SAN ANSELMO FLOOD RISK REDUCTION PROJECT

Final Environmental Impact Report
Volume 2 - Response to Comments
State Clearinghouse No. 2017042041

Prepared for
Marin County Flood Control and Water
Conservation District

August 2018

Figure RTC 2-1
Comparison of HEC-RAS Simulated Peak Water Surface Elevation (WSE) versus Observed High Water Marks (HWMs) for 12/15/2016 Flow Event – Corte Madera Creek (Units 2-4)

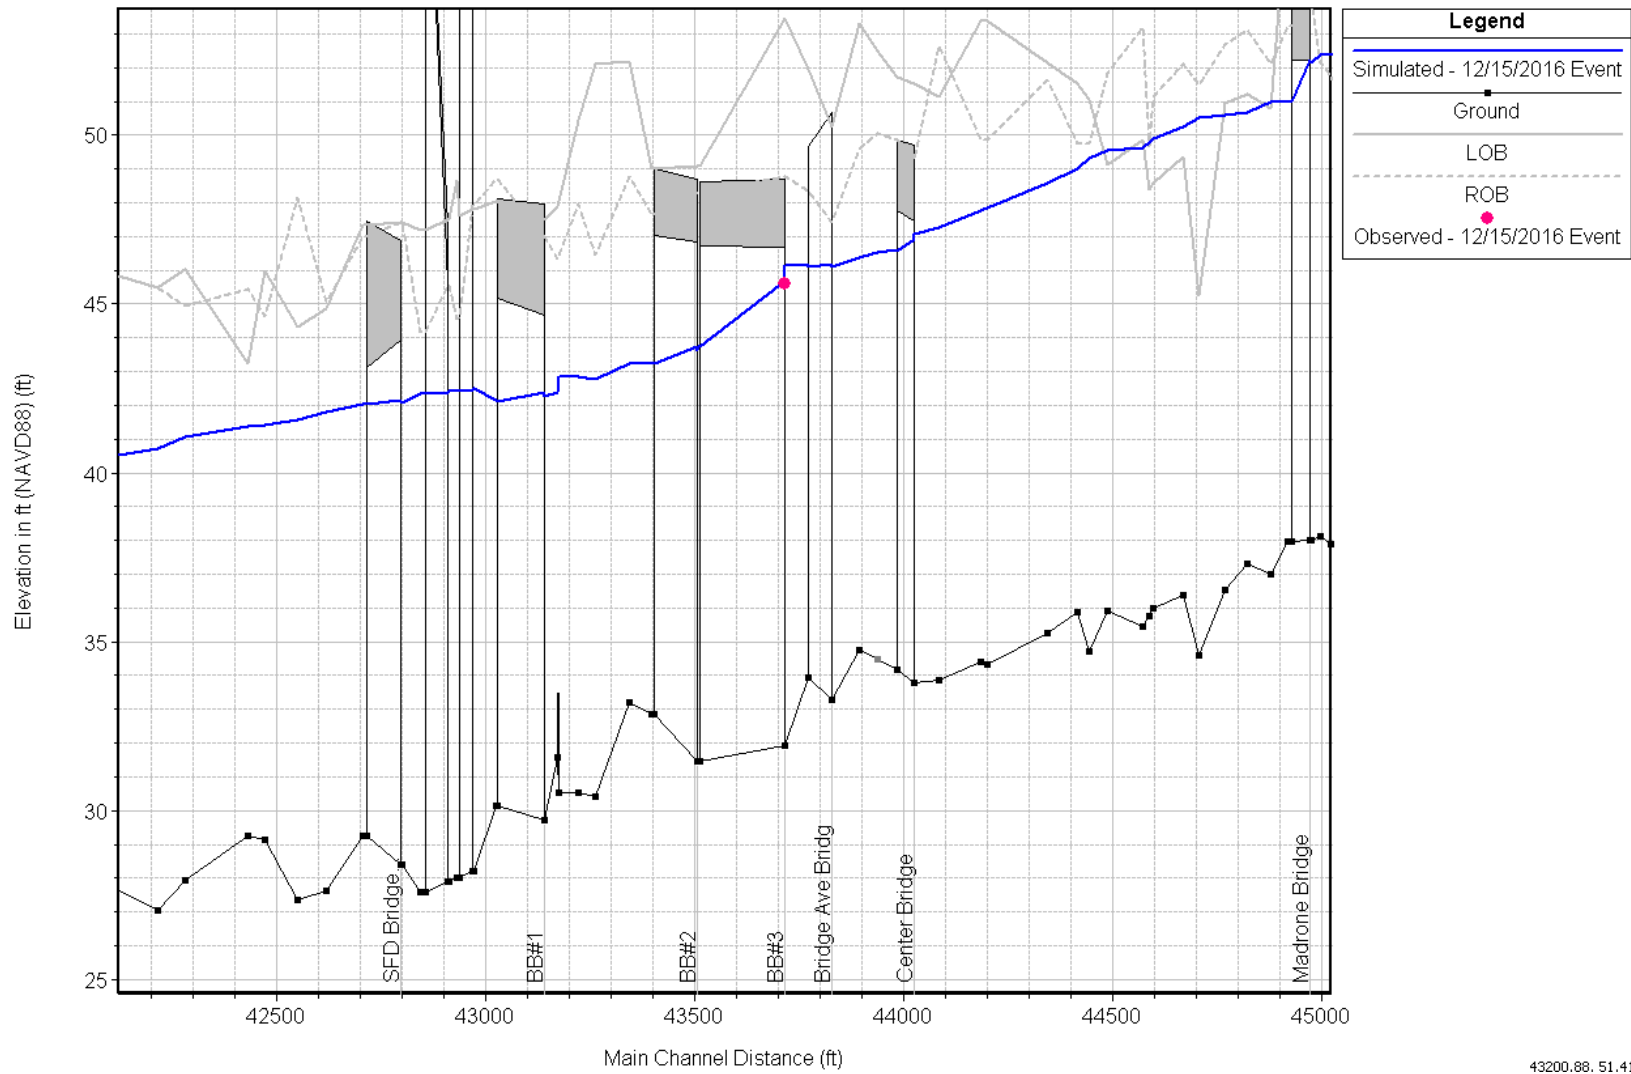
Multiple comments expressed concerns about the flooding model construction, calibration, and reliability, or generally expressed concerns about using a model to assess potential impacts. After an introduction to hydraulic models and associated terminology, this master response discusses the following topics for the Project flood modeling:

As described on Draft EIR page 4.9-39, the model was calibrated to one historical top of bank event¹⁷ (on December 15, 2016) and one historical approximately 100-year flood (on December 31, 2005) on Corte Madera Creek. The model was validated based on the January 4, 1982 flood event (an approximate 150-year flood event).

The model was first calibrated to the 12/15/2016 bankfull event by running and rerunning the model and adjusting the model's in-channel parameters with each iteration until the model-simulated peak water surface elevations satisfactorily matched the observed channel HWMs (refer to **Figures RTC 2-1 through 2-4** for the model calibration results). The model was then calibrated to the 12/31/2005 flood event by further adjusting the floodplain parameters until the model-simulated peak water surface elevations in the floodplain satisfactorily matched the observed floodplain HWMs. The model was finally verified to the 1/4/1982 flood event. For all the three events, simulation differences were well within the FEMA-required 0.5-foot range for most of the HWMs, particularly at locations where HWMs were considered most reliable.

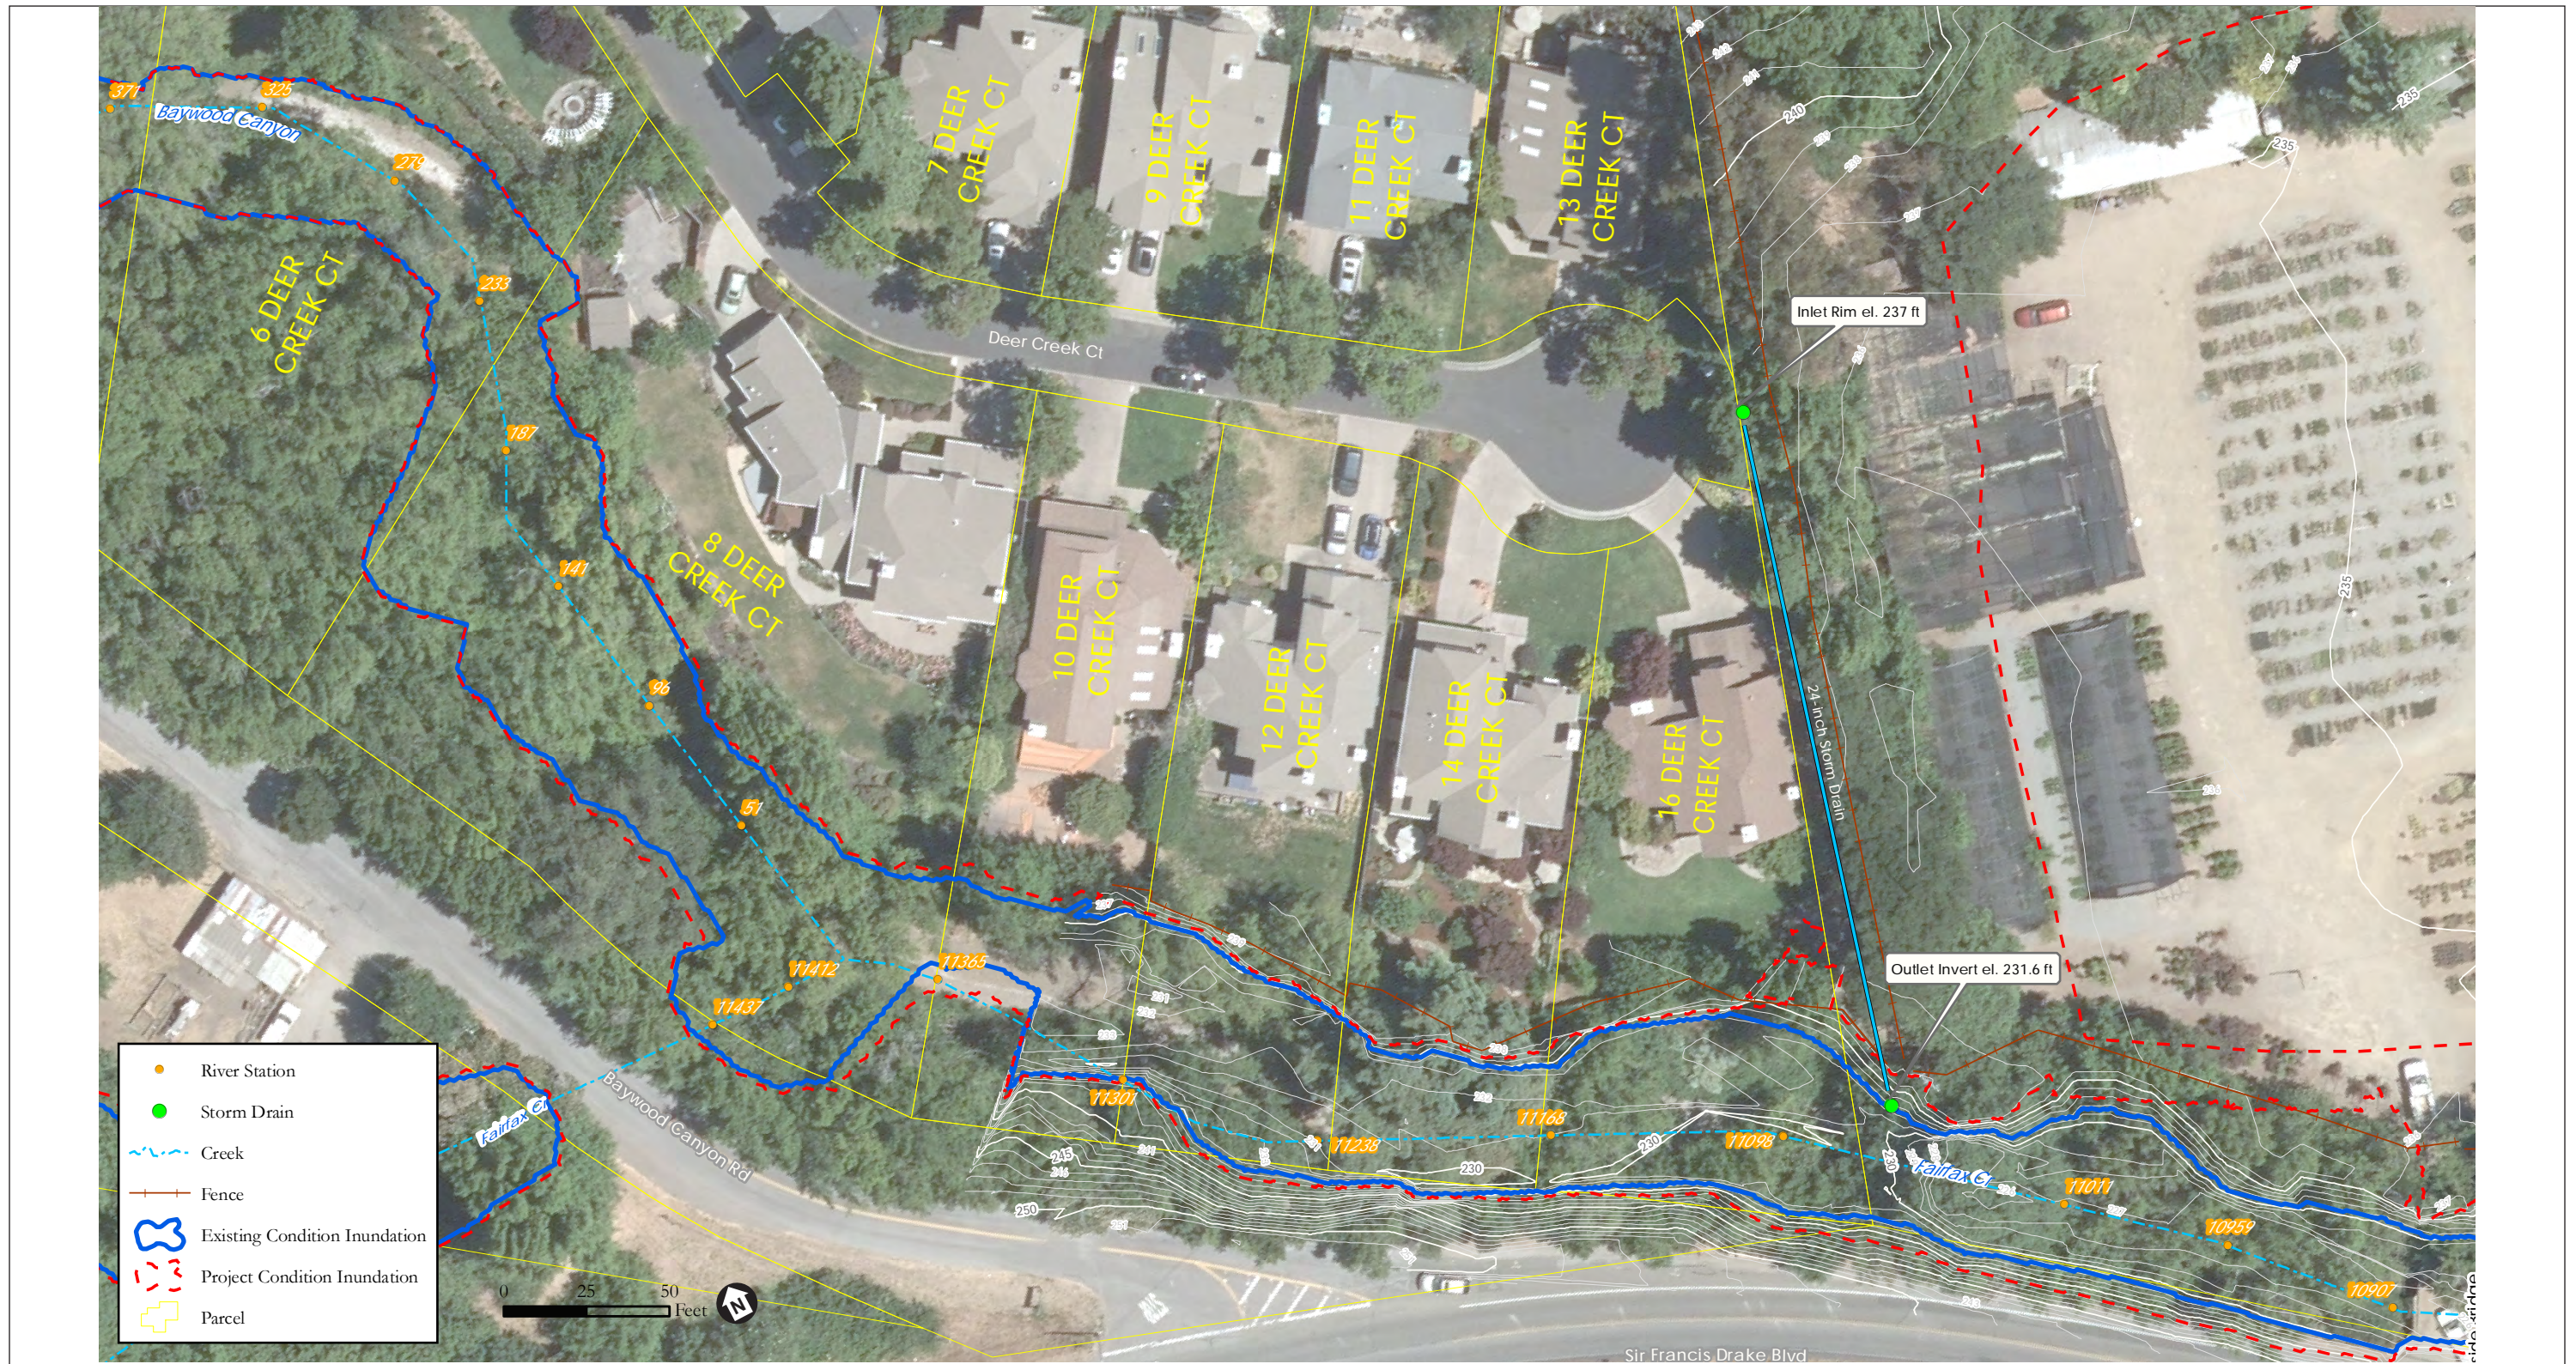
Multiple commenters requested more specific information about changes in flood risk and design of mitigation measures upstream of the Nursery Basin site and downstream of the building at 634-636 San Anselmo Avenue. This master response addresses the following topics in the subsections below.

As described in Draft EIR Impact 4.9-4, while annual sediment removal proposed as part of the Project would reduce the volume of sediment accumulated behind the diversion structure, a single event could produce enough sediment to cause new inundation during that same event; therefore, the Project’s impact on upstream flooding would remain significant. In addition to the planned sediment removal (discussed in text beginning on page 4.9-42 of the Draft EIR and as further explained in Master Response 7, Erosion, Sedimentation, and Channel Maintenance), Draft EIR Mitigation Measure 4.9-3a, Prioritize Nursery Basin Reach for Stream Maintenance, is proposed to reduce this risk by prioritizing sediment removal from this section of Fairfax Creek for regular removal under the Flood Control District’s Stream Maintenance Program. Mitigation Measure 4.9-4, Provide Flood Protection to Substantially Affected Properties, is proposed to address this potential upstream (i.e., backwater) flooding by implementing flood barriers.

The second type of new or increased flooding anticipated would occur in areas downstream of where the building at 634-636 San Anselmo Avenue would be removed. As discussed starting on Draft EIR page 4.9-52, Project operation would reduce flood risk in Fairfax, San Anselmo, and Ross on between 480 and 635 parcels (depending on the magnitude of the flood event), and would increase downstream flood risk on up to 17 parcels between Barber Avenue and the Sir Francis Drake Bridge during the 25-year flood event. As discussed in Draft EIR Impact 4.9-4, the FDS basin would retain stormwater that currently floods Fairfax and San Anselmo, reducing the volume of water that floods downstream into lower neighborhoods. Removal of 634-636 San Anselmo Avenue would allow water to remain in the channel; this would raise the water surface elevation of water pooling upstream of Winship Avenue, where the Winship Bridge currently constricts wet weather flows.
